MEMORANDUM

To: Design Review Board
From: Jon Regala, Senior Planner
Date: November 8, 2012
File No.: DRV12-00921
Subject: LAKE STREET PLACE - DESIGN RESPONSE CONFERENCE
(CONTINUED FROM OCTOBER 1, 2012)

Lake Street Place Project

Response to October 1st Design Response Conference:

2 ENLARGED COURTYARD PLAN
 1" = 10'

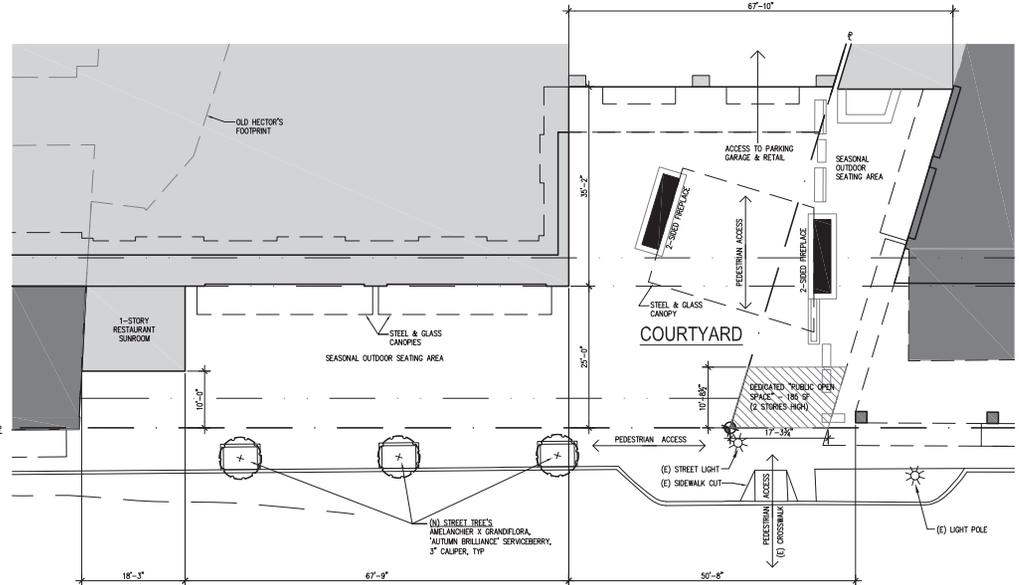
Lake Street – With the previous version of the project, portions of the 3^d and 4th story with the Hector's expansion and the KWM expansion were proposed to extend up to 5' into the required upper story 30' setback from Lake Street. The current version of the project only has 370 square feet of the KWM building extending into the required 30' setback from Lake Street. Based on this amount of area, the applicant is required by code to dedicate 185 square feet at the street level. The applicant is proposing to dedicate the required open space in the central courtyard along Lake Street.

- We are still asking the DRB to consider a 5'-0" setback reduction for the third and fourth stories at the Kirkland Waterfront addition. We are providing 185 square feet of two story high "public open space" at the street level which is shown drawing 2 of sheet 1.1.

5 STALLS

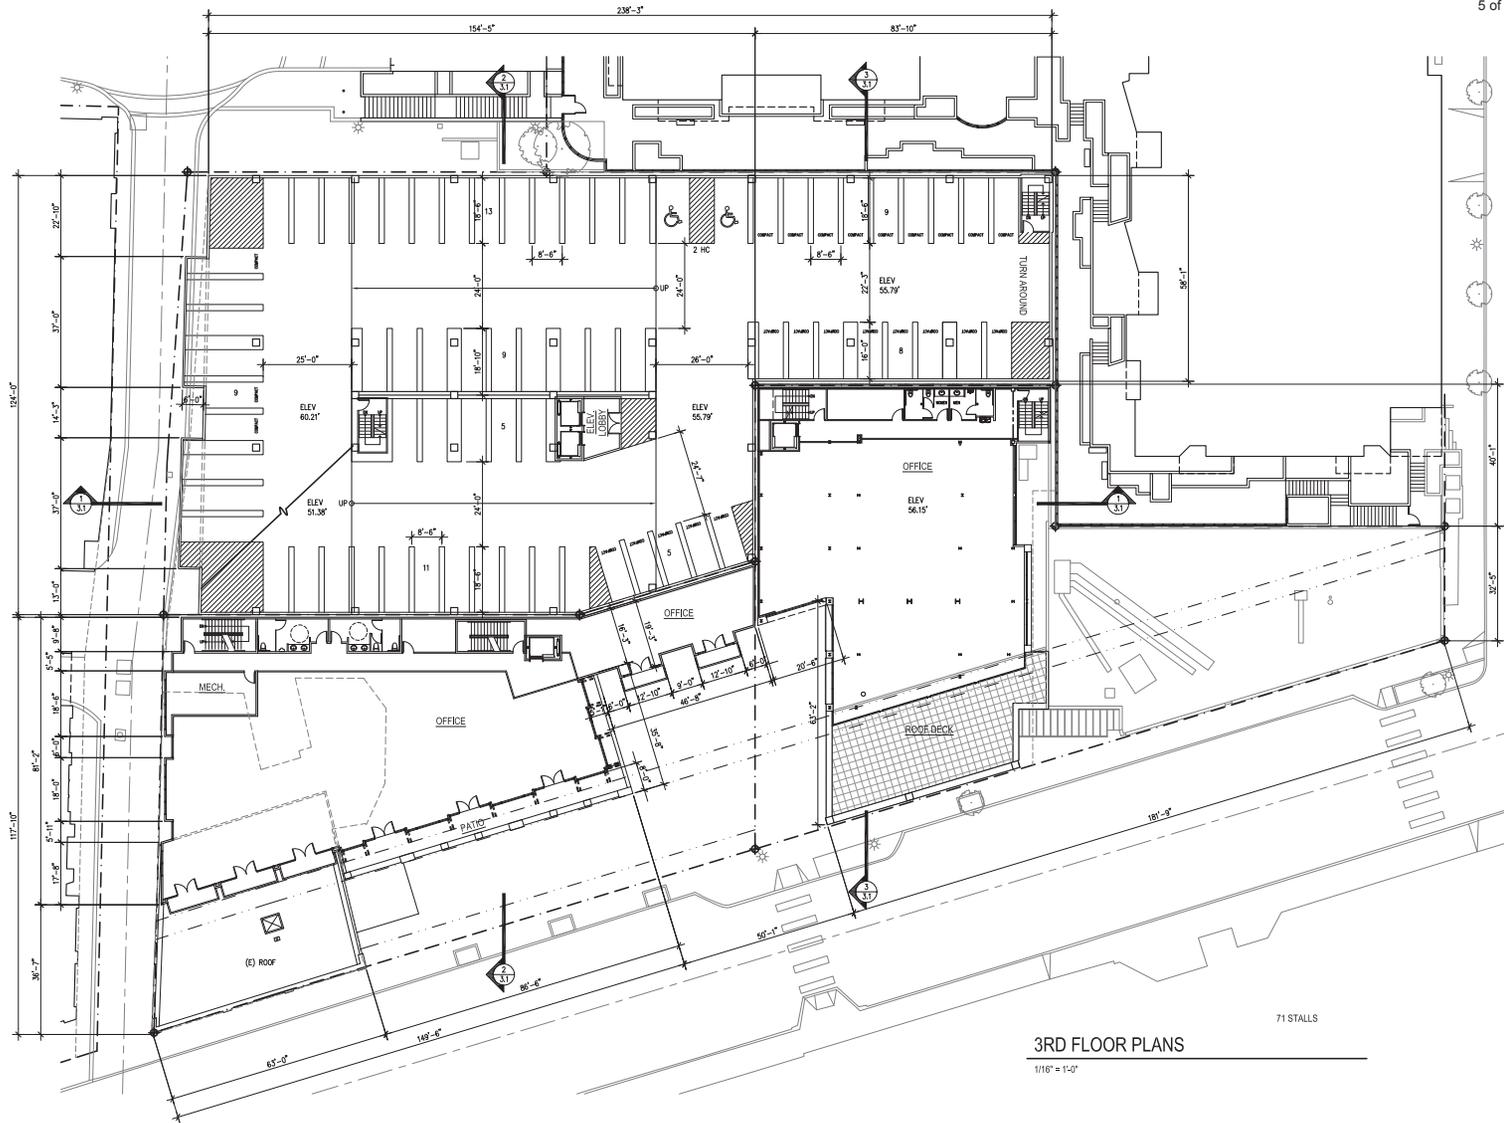
The new parking area located near the public walkway stair, which appears to accommodate only 5 parking stalls, should be reviewed by Public Works for vehicle and pedestrian circulation and safety.
3. Supporting Regulation. KZC Section 115.45 and 115.47 requires that garbage and recycling receptacles and loading and service areas are located to minimize visibility from any street, pedestrian walkway, or public park. Where visible, these areas are required to be screened.

Sheet No. **2.4**
 Project No. 1105
 Date: 07/30/12

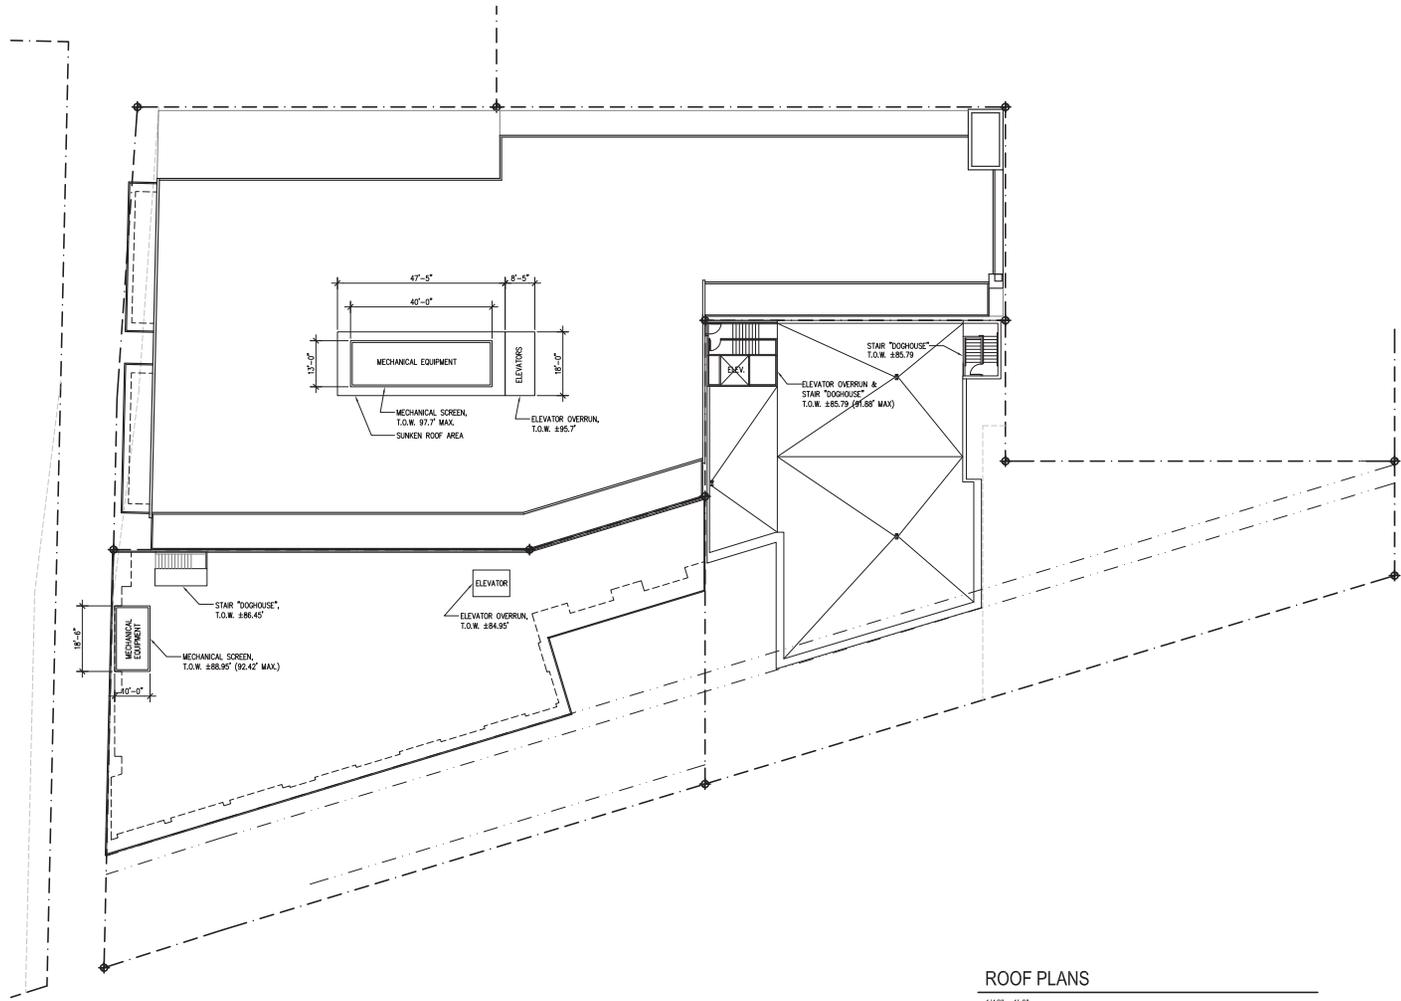
Main Street - Application of the upper story setback requirement along the Main Street right-of-way extension (at east property line) requires an area calculation to determine the amount of upper story building area to be removed within 40 feet of the property line. The calculation is:

Based on the above calculation, the project is required to remove 4,059.2 square feet of upper story building area above the second story within 40 feet of the Main Street right-of-way. The applicant's proposal to remove 4,518 square feet at the 5th and 6th story exceeds this requirement. Floors 5 and 6 are setback approximately 20' from Main Street. The final building massing arrangement should be determined by the Design Review Board as part of the design review process.

- To respond to concerns from neighboring properties we changed the program for the MSB and specifically to the upper floor Office plan. As shown on sheet 2.4 we stepped the southeast façade back 11'-0" from the property line to the window wall when previously we were only 3'-0" back from the property line. We also removed the parking on the roof of the northeast portion of the building. In doing so we enlarged the office floor plan and moved the east window façade so that it is still 22'-0" from the property line (maintaining our requirement for upper story setback).
